Access Compliance Report

Public Rights-of-Way

(Curb Ramps)

Intersection ID: 43653	Main Street: HUNTINGTON_MEADOW_LN	Cross Street: TAGGERT_TRAIL_DR	Location: SW
ADA ID: 476660BF9789	Ramp Type: Perp	Initial Pass/Fail: Fail	Overall Compliance: No
Severity Score: 12.5			
Codes/Mitigation Info/Possible Solution		Field Measurements/Component Compliance

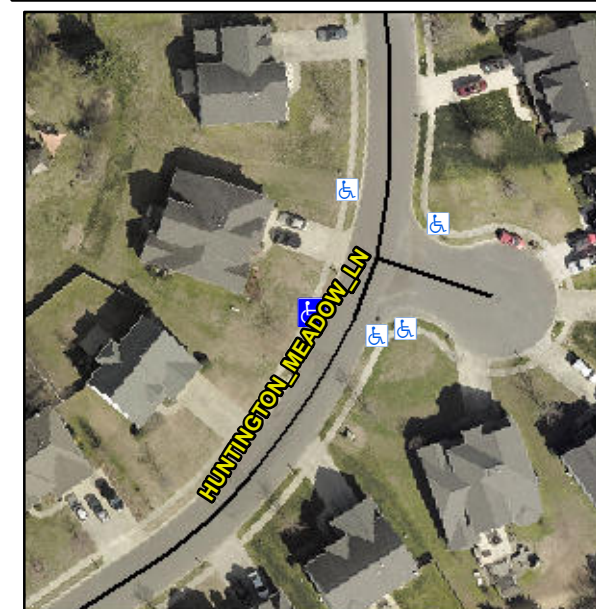
Not Found, R304.2.2

Compliance	Description	Data	Compliance	Description	Data
N/A	Ramp Length (in)	46.0	No	Ramp Slope (%)	11.3
Yes	Ramp Width (in)	49.5	Yes	Ramp XSlope (%)	0.9
N/A	Flare Type LT	N/A	N/A	Flare Type RT	N/A
N/A	Flare Slope LT (%)	N/A	N/A	Flare Slope RT (%)	N/A
N/A	Flare Traversable LT?	N/A	N/A	Flare Traversable RT?	N/A
N/A	Landing Length (in)	N/A	N/A	DWS Provided?	N/A
N/A	Landing Width (in)	N/A	N/A	DWS Contrast?	N/A
N/A	Landing Slope (%)	N/A	N/A	DWS Length (in)	N/A
N/A	Landing X Slope (%)	N/A	N/A	DWS Full Width?	N/A
N/A	Landing Curb? (Y/N)	N/A	N/A	DWS Offset (in)	N/A
N/A	Shared Landing?	N/A			
N/A	Gutter Ponding?	N/A	N/A	Gutter Slope (%)	N/A
N/A	Gutter Lip Ht (in)	N/A	N/A	Gutter X Slope (%)	N/A
N/A	Painted X Walk1?	No	N/A	Painted X Walk2?	N/A
	X Walk 1 Direction	To E		X Walk 2 Direction	N/A
N/A	X Walk 1 Width (in)	N/A	N/A	X Walk 2 Width (in)	N/A
	X Walk 1 Slope (%)	1.6		X Walk 2 Slope (%)	N/A
	X Walk 1 X Slope (%)	0.8		X Walk 2 X Slope (%)	N/A

Remove & Replace Entire Ramp.
